SECTION 00806

CHANGE ORDER

OWNER St. Charles Parish Department of Public Works
CONTRACTOR All Star Electric, Inc.
Contract: Eastbank Historical Lighting
Project: Eastbank Historical Lighting
OWNER's Contract No. P030704 ENGINEER's Contract No. 20-0322
ENGINEER Meyer Engineers, Ltd.

ATTACHMENT NO. 1
CHANGE ORDER NO. 1
EASTBANK HISTORICAL LIGHTING
PUBLIC WORKS # P030704
A/E PROJECT NO. 20-0322 MAY 14, 2004

sheet no. 19

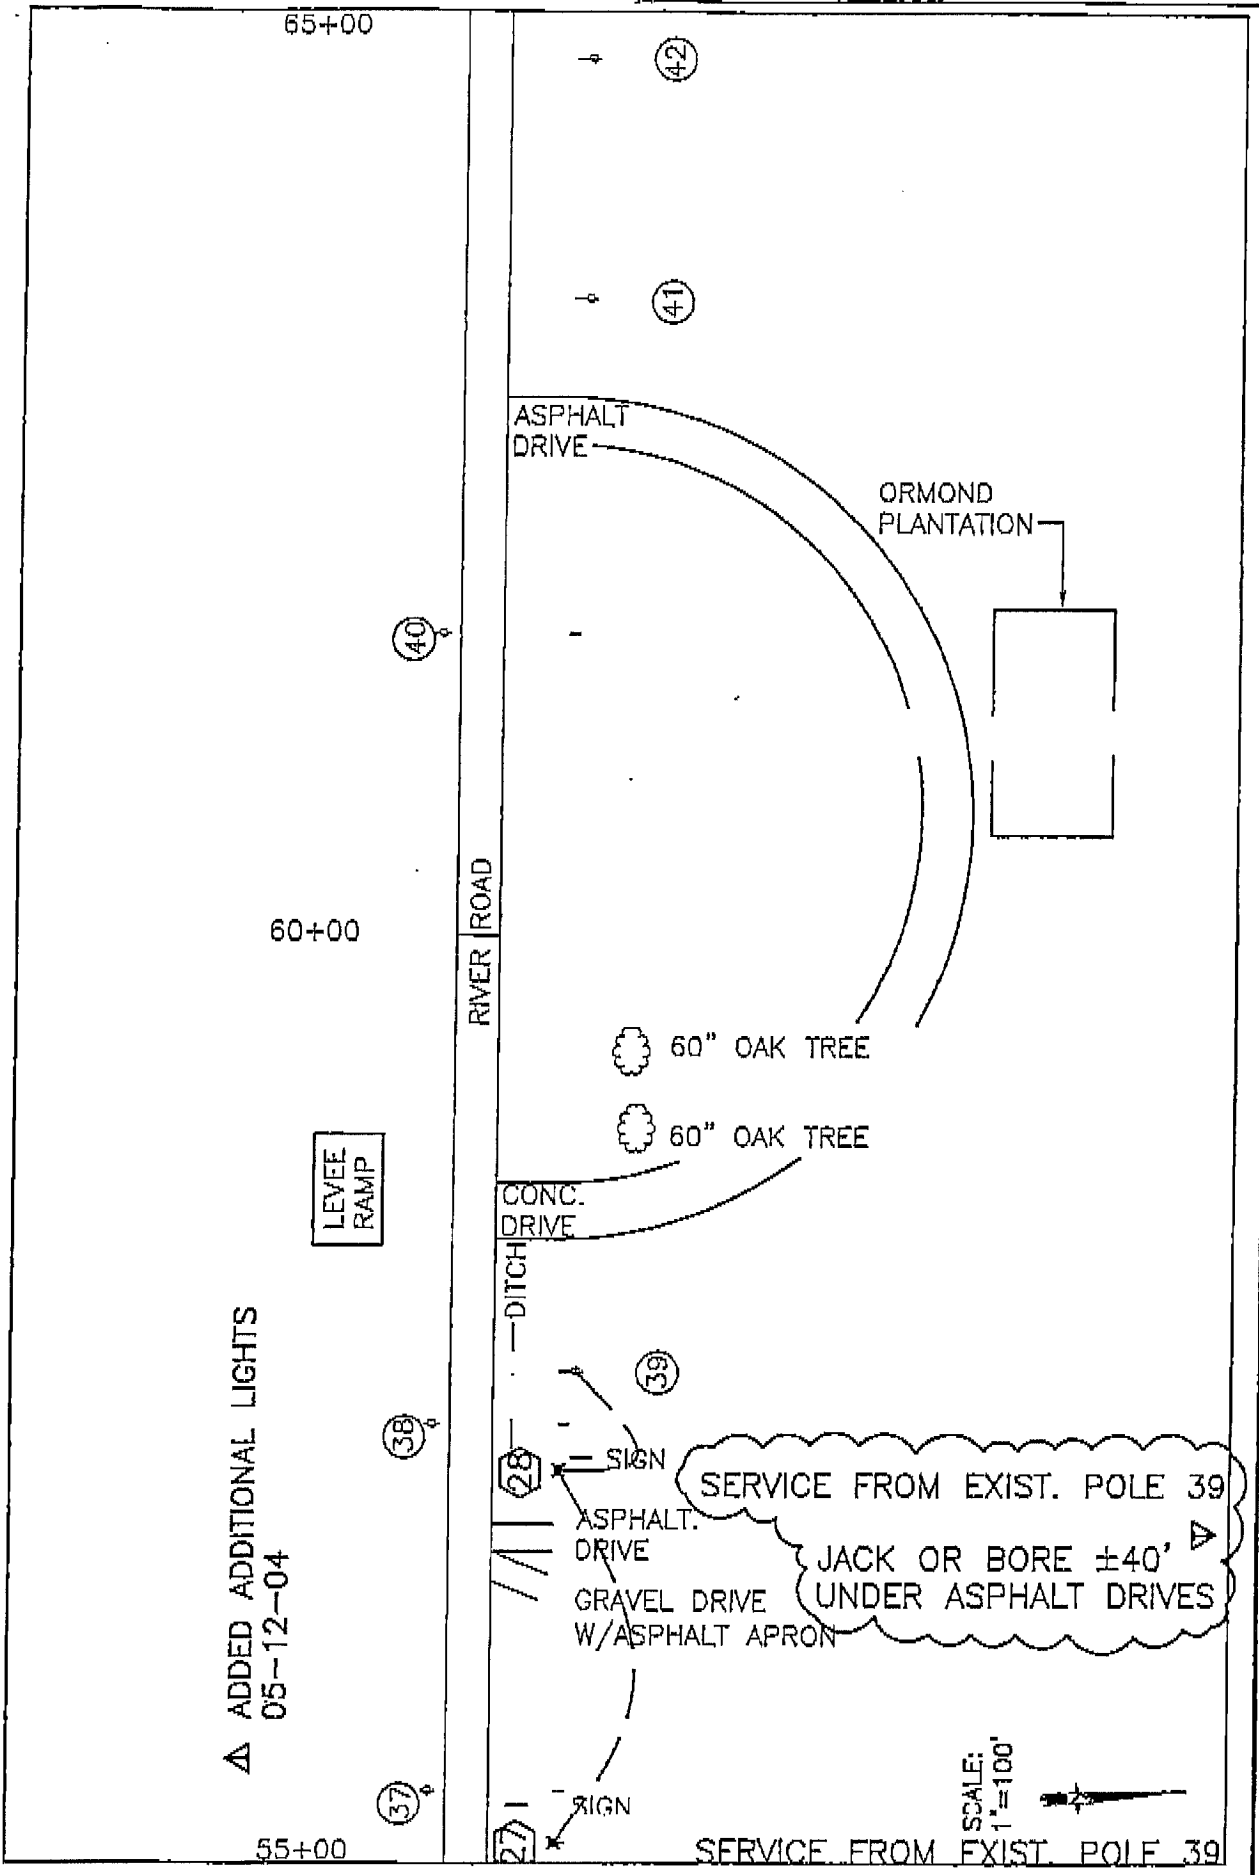
Enclosed are three (3) copies of revised sheet 19 and additional sheet 20 dated May 12, 2004.

△ REVISED TO CLARIFY JACK OR BORE AREAS 02-09-04

△ ADDED ADDITIONAL LIGHTS 05-12-04
